Site Accessibility Evaluation

Americans with Disabilities Act Title II (Public Services: State and Local Government)

Fountain Creek Nature Center

Accessibility Evaluation

Finding: 3

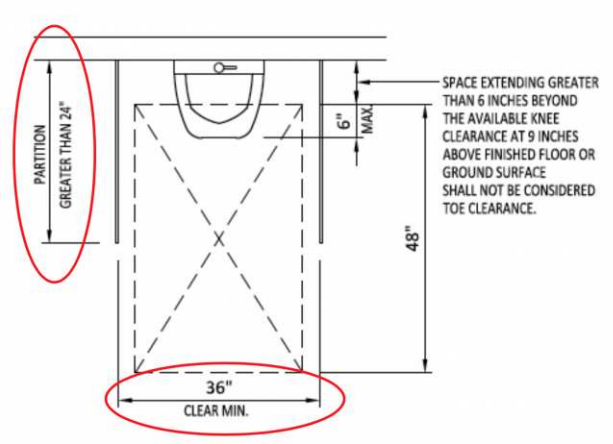
The urinal is confined on three sides (alcove).

Forward approach
measures 31 inches

Due to limited space and placement/protrusion of the changing table into the minimum required cleared floor space for a forward approach, the required 36 inches may not be met. Recommend reconfiguration if and when renovation/remodel is performed to meet compliance.

Finding: 4

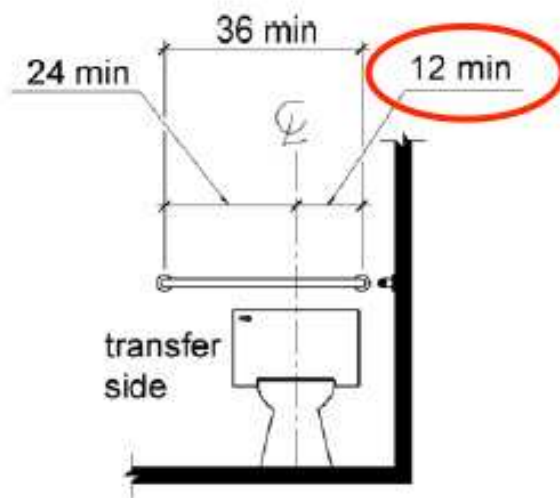
The rear grab bar does not extend adequately past the centerline of the toilet on the wall side.

10.5 inches from
centerline of toilet

Re-position rear grab bar to extend 12 inches minimum on wall side and 24 inches minimum on the transfer side measured from the centerline of the toilet.

Finding: 5

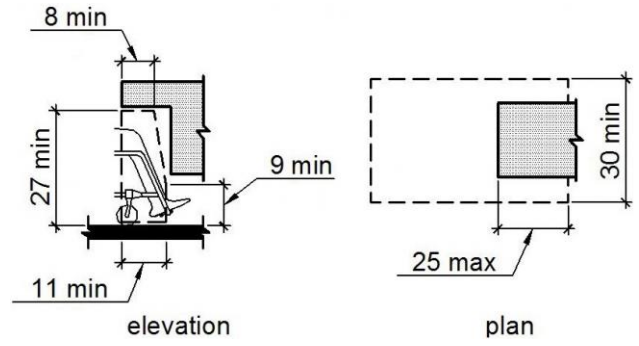
The knee clearance not compliant.

26.5 inches above
finished floor

Lower baby changing station to meet the 27 inches minimum required under an element for knee clearance, 28 inches minimum to 34 inches maximum to the top of the table surface and 48 inches maximum height to operable part measured from the finished floor.

Finding: 6

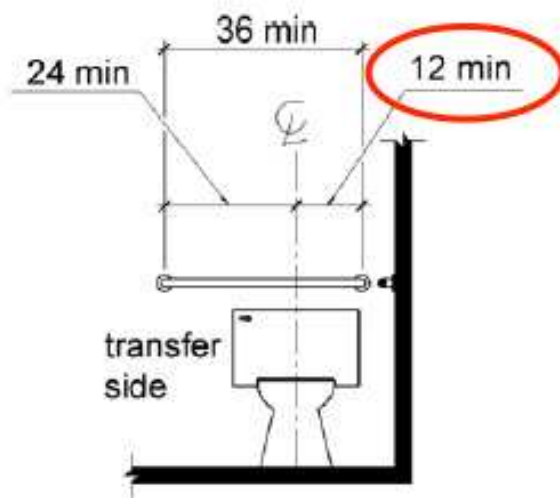
The rear grab bar does not extend adequately past the centerline of the toilet on the wall side.

10.5 inches from
centerline of toilet

Re-position rear grab bar to extend from the centerline of the toilet 12 inches minimum to the wall side and 24 inches minimum to the transfer/open side.

Finding: 7

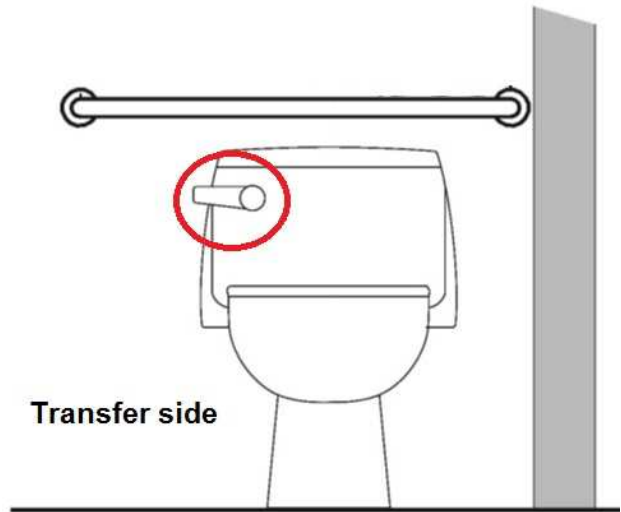
The flush handle is located on the wrong side of the toilet.

Flush handle located
on the closed side

Replace toilet water tank with one that has flush handle on the opposite side (open side of toilet area).
